# Response to Submissions

Girraween Waste Recycling and Transfer Facility  
224–232 Toongabbie Road Girraween

State Significant Development 9766

Prepared for  
BENEDICT RECYCLING PTY LTD  
MARCH 2020

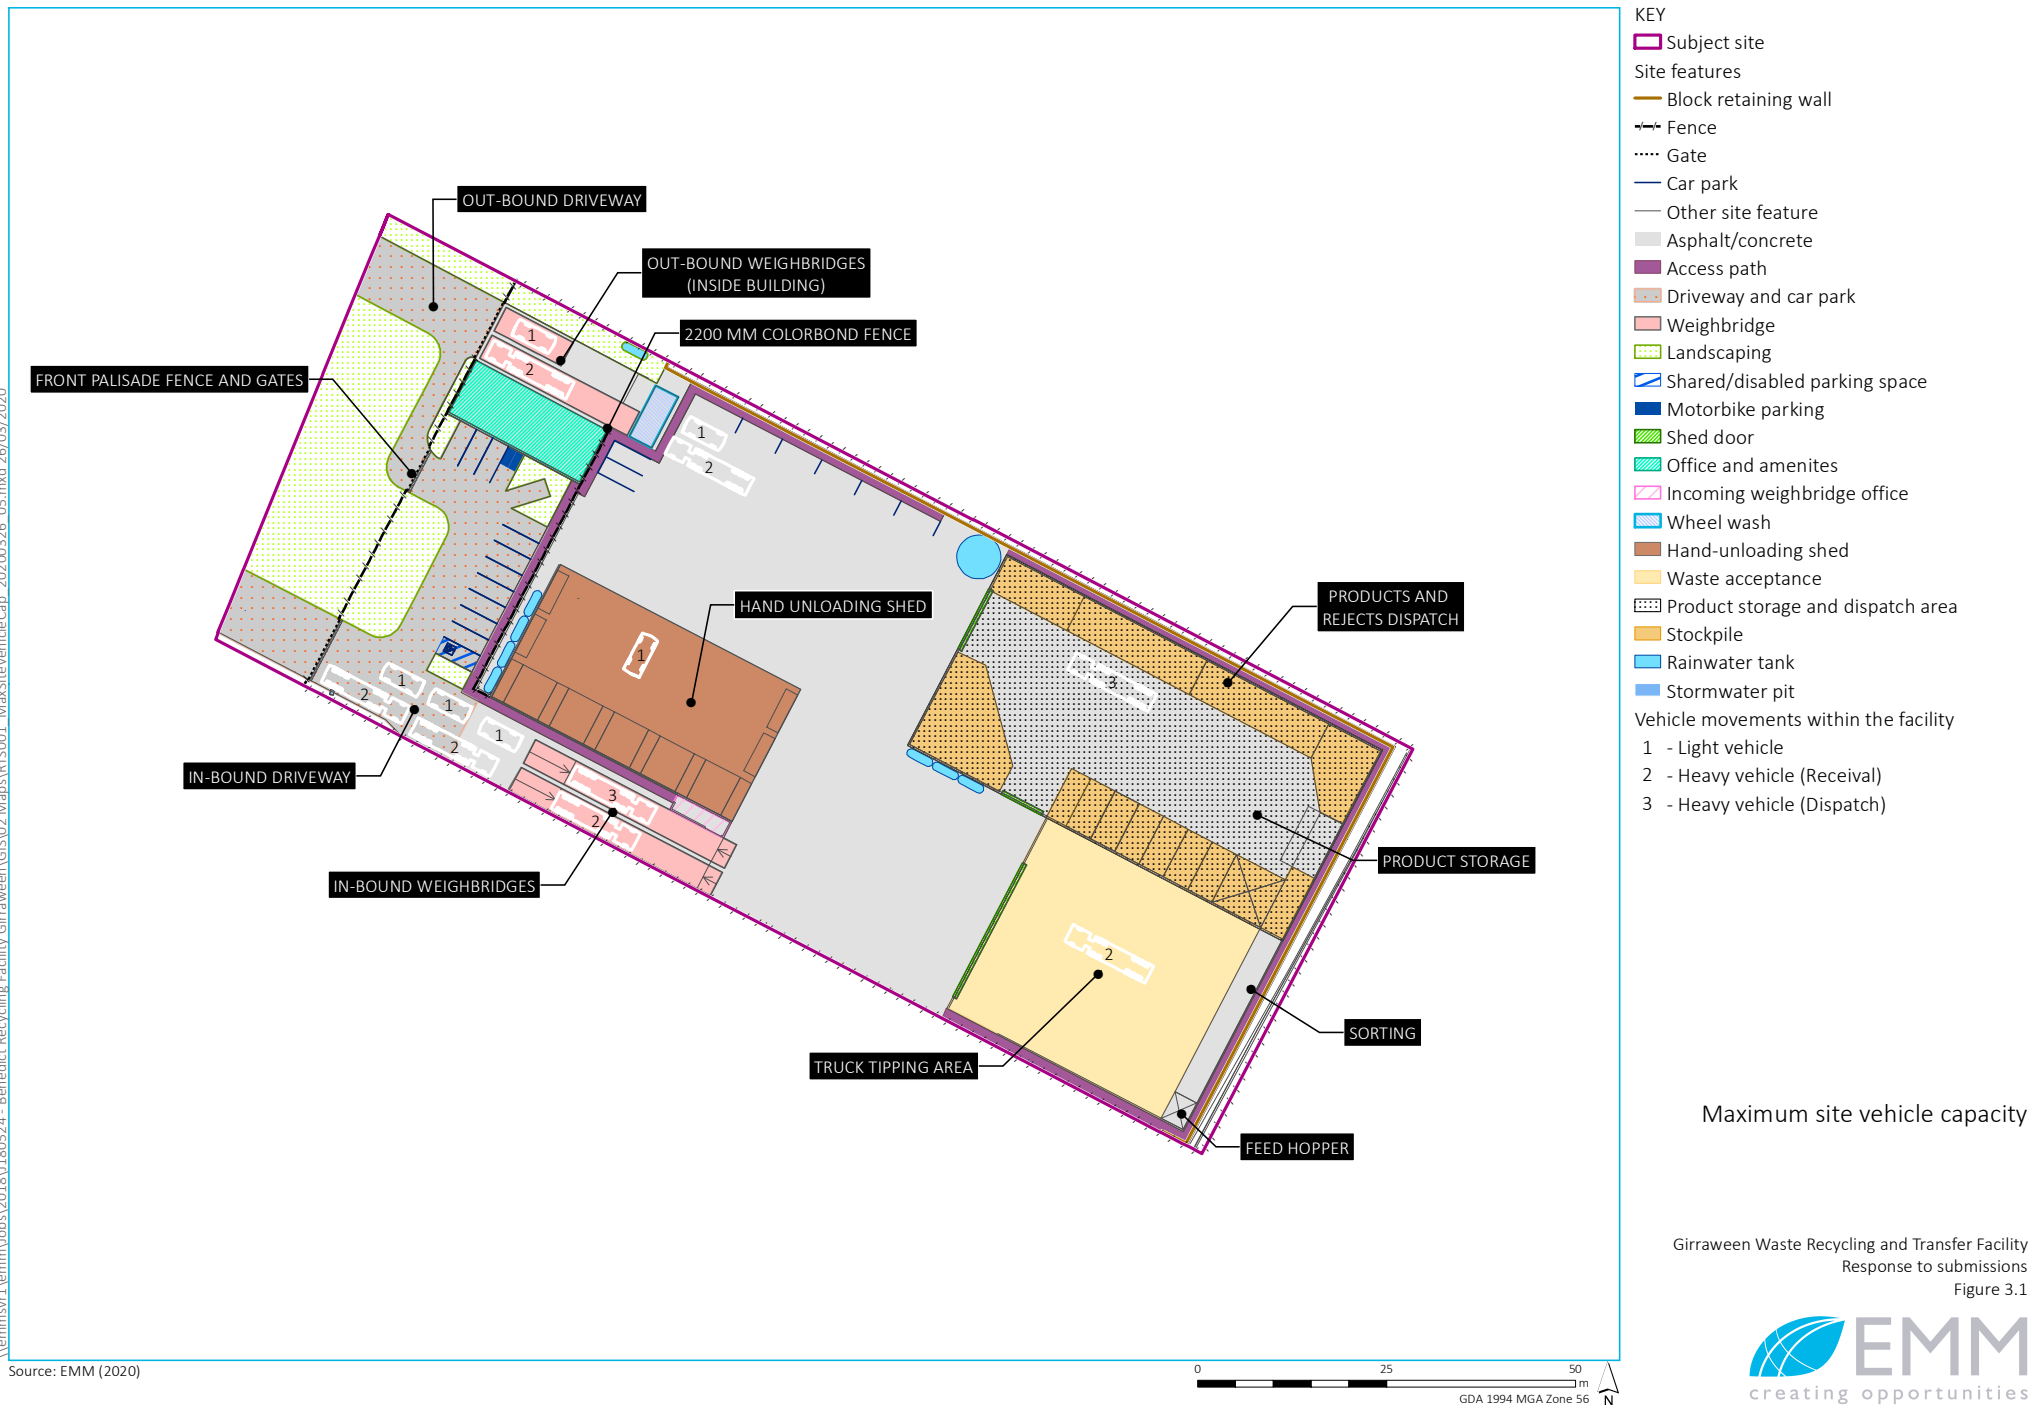
***Detail how peak times in relation to delivery will be managed. Provide details of the maximum safe capacity of the site in terms of vehicles and people, how often the site's capacity would be reached, measures to manage the site to ensure safe operations should this capacity be reached.***

***Based on the proposed processing capacity, peak delivery times and the duration of time the truck is onsite, provide a worst-case scenario of vehicle stacking onsite. This should be in the form of a scaled plan.***

The site's maximum vehicle capacity is shown in Figure 3.1, demonstrating that a total of 14 vehicles can be adequately accommodated on the site, comprising:

- 6 light vehicles (waste receivals);
- 6 heavy vehicles (waste receivals); and
- 2 heavy vehicles (dispatch).

The calculations for the maximum vehicle capacity have adopted a worst-case assumption that all vehicles within the 14-minute snapshot would arrive on site within the two minutes it takes to enter and exit the incoming weighbridges. Further, the total number of vehicles on site (column 4 of Table 3.3) has been rounded up from the number of vehicles calculated for the 14-minute snapshot (column 3 of Table 3.3).

It is noted that front end loaders would not operate whilst trucks are moving and, therefore, they have not been included in Figure 3.1.

In summary, the site has the capacity for 14 vehicles. There would be a maximum of seven vehicles on site during the site-peak hour (typically 1:00 pm to 2:00 pm ) so there would be ample capacity on the site at all times. Accordingly, vehicles would not need to queue for on Toongabbie Road prior to entering the site.

As described above, Figure 3.1 shows the stacking of vehicles on site and demonstrates the capacity of the site during the midday peak period.

**Plate 3.1** Excerpt of Council flood mapping showing extent of 1% AEP storm event

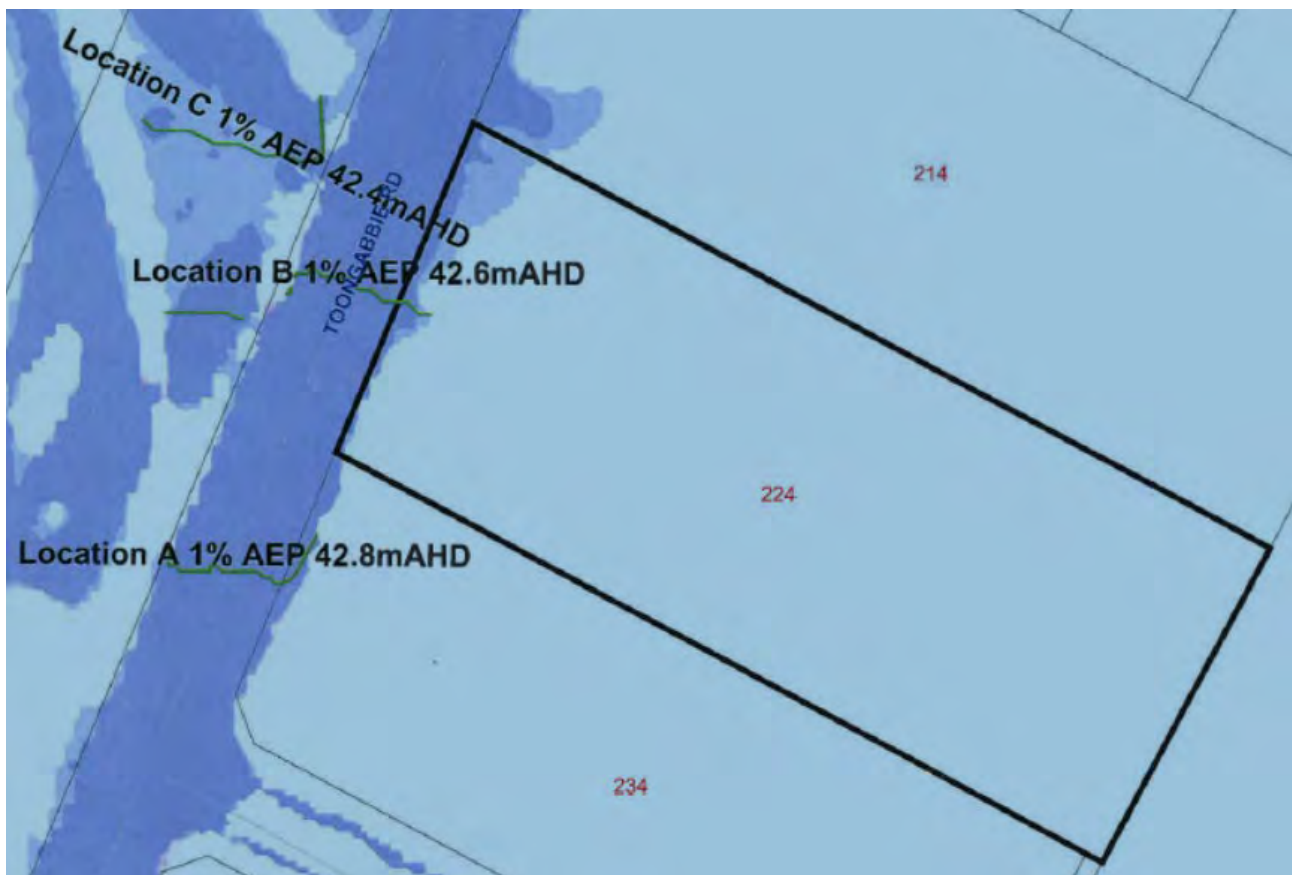
- (i) The applicant shall submit a survey drawing prepared by a registered surveyor that includes existing site contours and spot levels throughout the site along with the location of all existing structures to the Australian Height Datum (mAHD).***
- (ii) Ensure that the finished floor level of the proposed warehouse is set a minimum of 500mm above the 1% AEP overland flow path level, at the upstream side of the structure and that the carparking is a minimum of 150mm above the same.***
- (iii) Reference shall also be made to Holroyd DCP 2013 Part A section 8 including the Flood Risk Precincts table.***
- (iv) Council flood information can be made available upon submission of the flood advice application to Council.***
- (v)***

A survey plan is provided in the project plans (Appendix A). An excerpt of flood mapping provided by Cumberland Council which shows the location of the 1% annual exceedance probability (AEP) storm event, is provided below. The majority of the site is identified as being within a medium flood risk precinct pursuant to the Holroyd DCP 2013, which is defined as land below the 1% AEP. Development within this precinct is possible, subject to appropriate management measures, to ensure the safety and protection of both person and property during a critical storm event. As shown on the plan excerpt, the 1% AEP only includes a small area at the very front of the site. The proposed car parking area and site buildings are set back from this and the finished floor level of the car park and the proposed buildings would be a minimum of 150 mm and 500 mm, respectively, above the 1% AEP level.
